RE: Subdivision & Site Plan Approval
Bedford EMP Ownership, LLC - Robert Morse
50 East Middle Patent Road
North Castle (T)

Our office has revised our plans pursuant to the July 6, 2021, Staff Report prepared by the Town Planner and the July 9, 2021, memorandum prepared by Kellard Sessions, Consulting Town Engineer. We offer the following responses for the Board's consideration:

SITE PLAN - LOT 1		DATE:	9-13-2021
MORSE SUBDIVISION 50 EAST MIDDLE PATENT ROAD TOWN OF NORTH CASTLE, WESTCHESTER COUNTY		SCALE:	1" = 30'
BIBBO ASSOCIATES, LLP 295 ROUTE 100 SUITE 203 SOMERS, NEW YORK 10589 TEL. 914 277 5805		FILE:	1-E
		DSGN/CHK:	MG
		DRN. BY:	RH
		SHT NO.:	1 OF 4
		DWG NO.:	SP-1

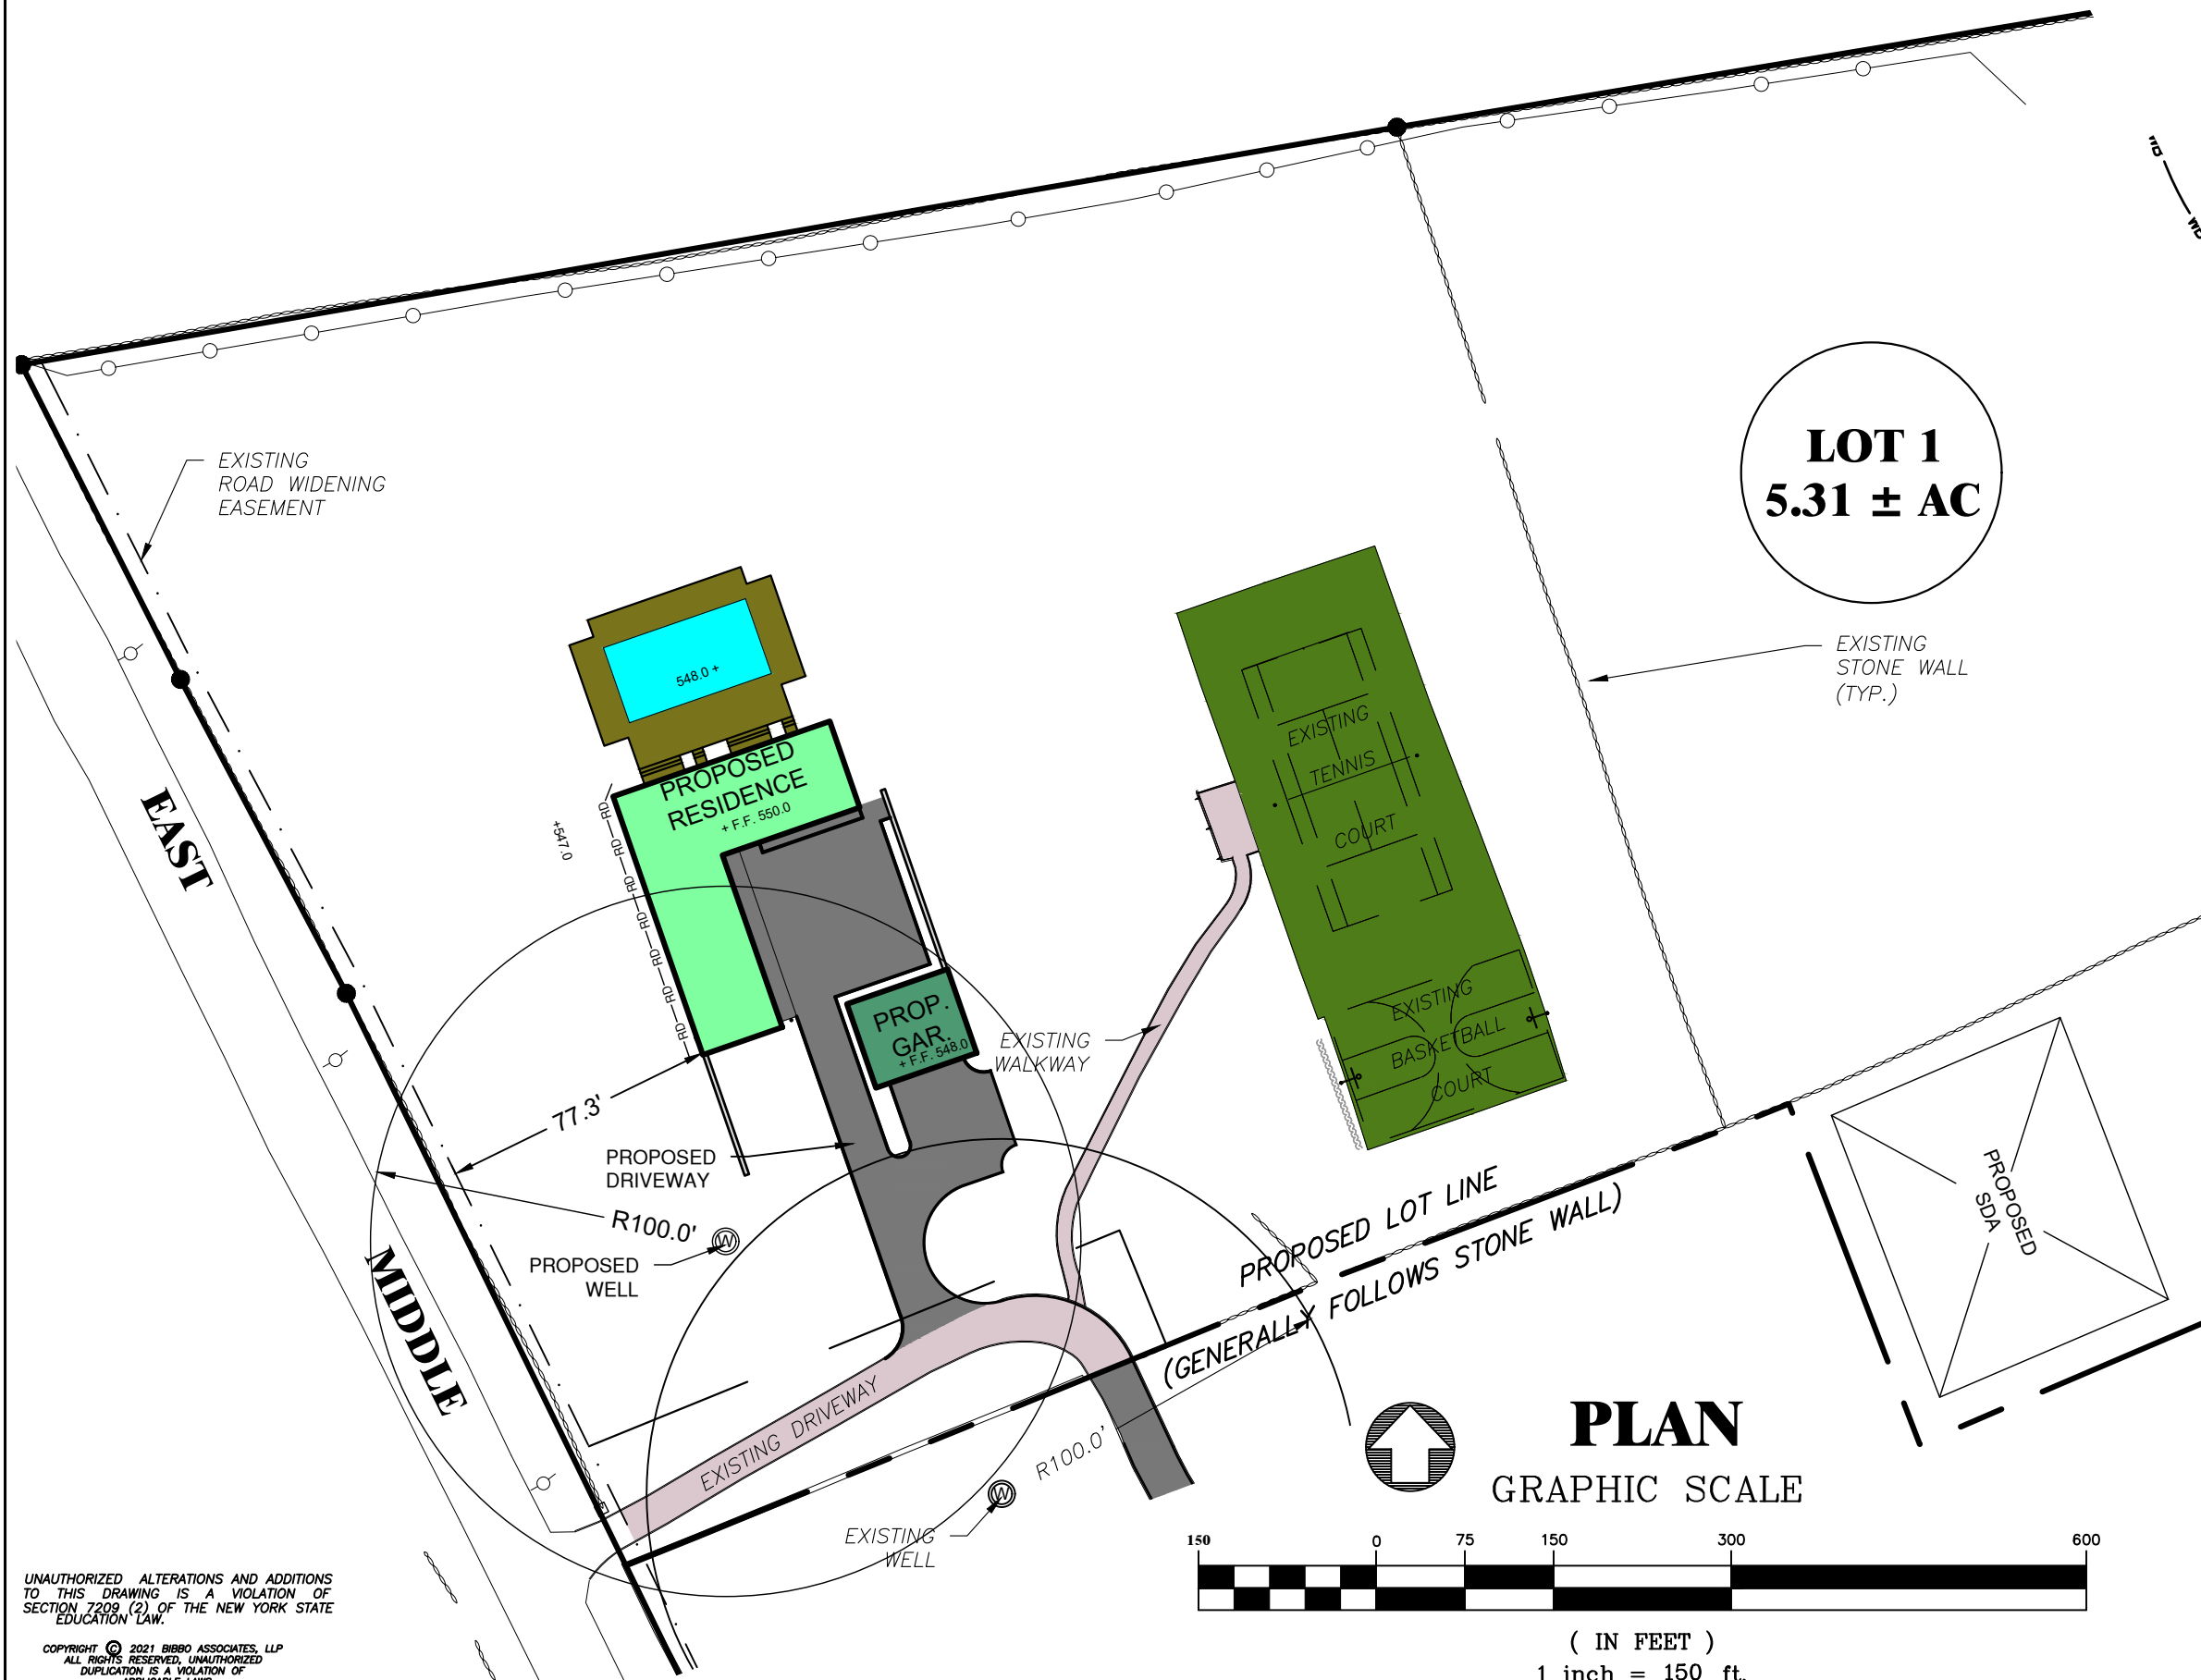
- (3) Comment noted.
 - (4) Comment noted.
3. A site plan and application for site plan approval for proposed lot #1 are enclosed, the size of the proposed detached garage has been shown on the Lot 1 Gross Land Coverage Exhibit. Architectural plans and application for special permit will be provided under separate cover.

11. Gross Land Coverage Calculation worksheets have been prepared with supporting exhibits II and III for each lot. These documents have been included as part of this submission.
